Technical Service Bulletin		GROUP	NUMBER		
		CAMPAIGN	16-01-071		
		DATE	MODEL(S)		
		DECEMBER 2016	SONATA 2.0T (YF) SANTA FE SPORT 2.0T (AN)		
SUBJECT:	THETA 2.0L TURBO OIL FEED HOSE REPLACEMENT				
	(SERVICE CAMPAIGN T1N)				
* IMPORTANT	*** Retail Vehicles Only ***

Description: Some Sonata 2.0T (YF) and Santa Fe Sport 2.0T (AN) vehicles may experience a slight leak from the oil feed hose assembly onto the engine undercover directly beneath the hose.

This bulletin provides the service procedure to replace the oil feed hose with a revised service part.

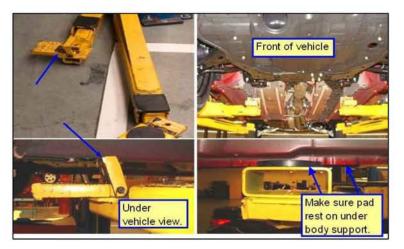
Replace the Oil Feed Hose (A) according to procedure outlined in this bulletin and the applicable Shop Manual.

- Make sure the stopper (B) doesn't touch the compressor housing during the installation.
- DO NOT reuse the gaskets.
- Clean the gasket installing surfaces before the installation of the gaskets.
- 1. Secure the vehicle on a lift.
 - Ensure that the vehicle is properly positioned on the lift.
 - Lifting points should not contact any exterior body parts such as the rocker panel.
- 2. Rotate the steering wheel fully to the left to create more working clearance for later steps.
